Application No.: 10/627,833
Amendment dated: 06/27/2005

Reply to Office action of 04/07/2005

REMARKS/ARGUMENTS

Fig. 8 Prior Art

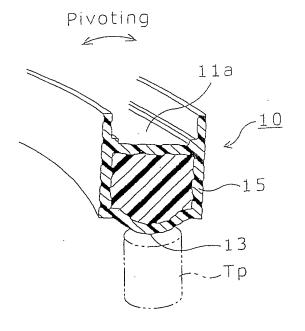
Figure 8 is now properly labeled as "Prior Art".

Please replace the sheet bearing FIG. 8 with the attached replacement sheet. An annotated sheet of the drawing, showing the changes, is also attached.
